Re: Development Application 10115 for the Replacement of the Mount Perisher Double and Triple Chairlifts with a Six-Seater Chairlift, Mount Perisher, Perisher Ski Resort

Dabyne Planning Pty Ltd has been engaged to prepare a further response on behalf of Perisher Ski Resort in relation to the above Development Application.

This is provided in response to the Department of Planning, Industry and Environment letter dated 21 October 2020, NSW Fisheries letter dated 23 September 2020 and NPWS letter dated 28 September 2020.

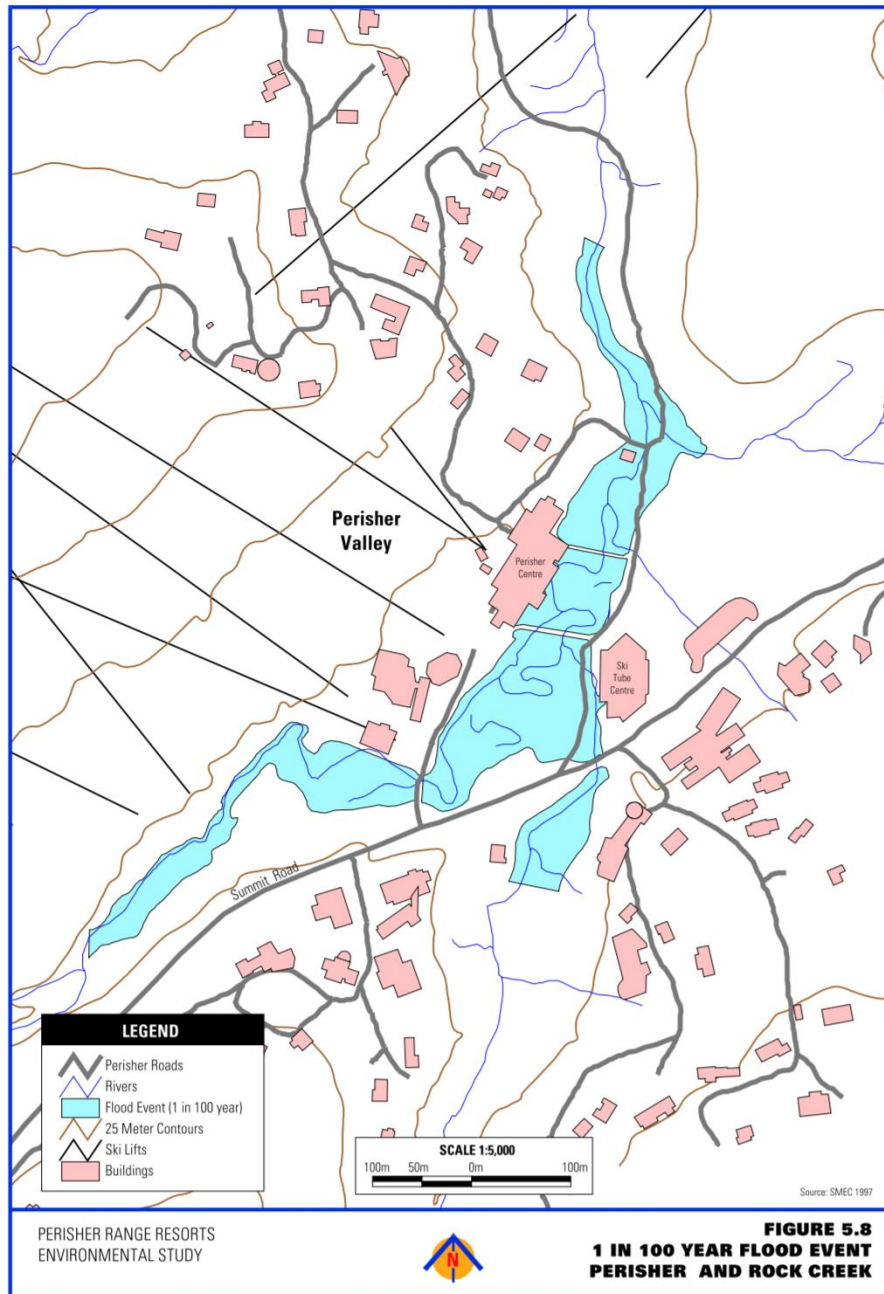
The Department has requested that further consideration of the 'Fish passage requirements for waterway crossings' as referred to in the NSW Fisheries comments be undertaken.

This issue and further request for additional information appears to be generated by a misunderstanding of the proposed crossing, as an open-bottom box culvert will be used to form a bridge and is not a traditional 'culvert' as referred too with examples provided in the NSW Fisheries guidelines.

Photos of a similar open-bottom box culvert used to cross the same creek downstream (provided previously and below) shows that the structure is fundamentally a 'bridge' and therefore does not interfere with fish passage.

As shown in the photos below the width of the width of Perisher Creek at the proposed culvert location adjacent to the existing Mt Perisher deck is typically 1 metre wide.

The proposed open-bottom pre-cast concrete bridge span is 4.2 metres. The width is also 4.2 metres (ie 4x 1.2metre precast sections) and a revised design has been provided by CLM Civil which includes the installation of armour rock along the embankment.

- the open-bottom box culvert bridge would be of sufficient size to avoid any reduction in the cross-sectional area of the active channel, to prevent increased discharge velocity and upstream pooling and sedimentation caused by flow constriction (including during high flows)
- no pillars or abutments would be installed within the stream bed, including high flow levels. Abutments would be set above high water flow levels; and
- the open-bottom box culvert bridge design would allow the natural bank profile, bed level and bed substrate to be retained.

The open-bottom box culvert bridge is wider than the creek embankments down stream and is wider than the channel upstream, therefore it is not able to funnel water flows or impact on fish passage.
